BCAC Public Comment Proposals

June 9, 2021 Meeting

G201-21

IBC: 3115.3, 3115.3.2 (New), FIGURE 3115.3.2 (New), 3115.8, 3115.8.1, 3115.8.1.1, 3115.8.2, 3115.8.3, 3115.8.3.4 (New), FIGURE 3115.8.3.4 (New), 3115.8.3.4.1 (New), 3115.8.3.4.2 (New), 3115.8.4.1, 3115.8.4.2, 3115.8.4.3, 3115.8.3.4.1 (New), 3115.8.3.4.2, 3115.8.5, 3115.8.5.1, 3115.8.5.2, 3115.8.5.3, TABLE 3115.8.5.3, ISO Chapter 35

FIGURE 3115.3.2 MARKING IDENTIFICATION AND LIKELY LAYOUT

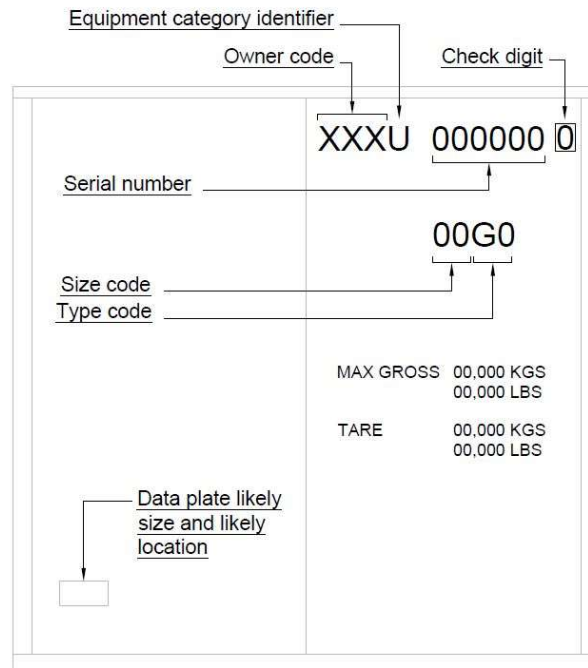
3115.3.2 Intermodal shipping container markings. *Intermodal shipping containers* shall have markings, separate from the data plate, containing the following information. Refer to Figure 3115.3.2 for an example layout of the markings.

Re 3115.3.2: This section is added such that the requirements that ISO 6346 requires be marked on the containers are verified, and have the correct type code, such that conformance to ISO 1496-1 can be determined by these markings.

FIGURE 3115.8.3.4 CONTAINER ELEMENT IDENTIFICATION

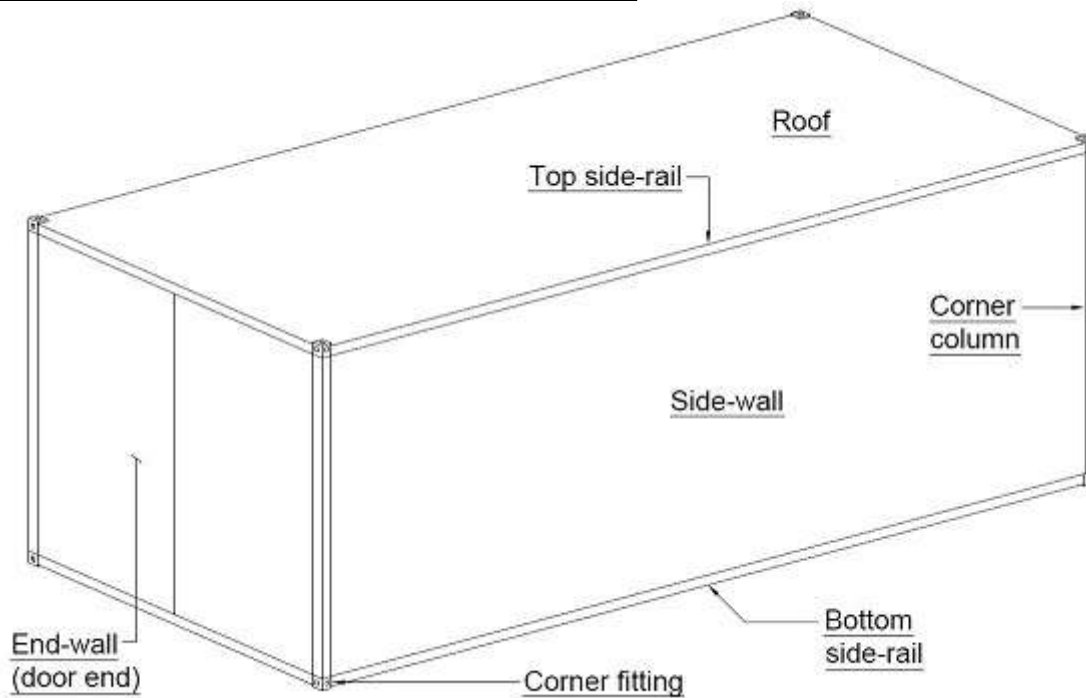
3115.8.3.4 Tested structural components. Where they are not altered, the structural components identified in Section 3115.8.3.4.1 and 3115.8.3.4.2 can be used with the load combinations of Section 1605.3 based on the testing performed during the *intermodal shipping container* certification process. This certification shall have been verified by the data plate and markings in Section 3115.3. The components names are labeled in Figure 3115.8.3.4.
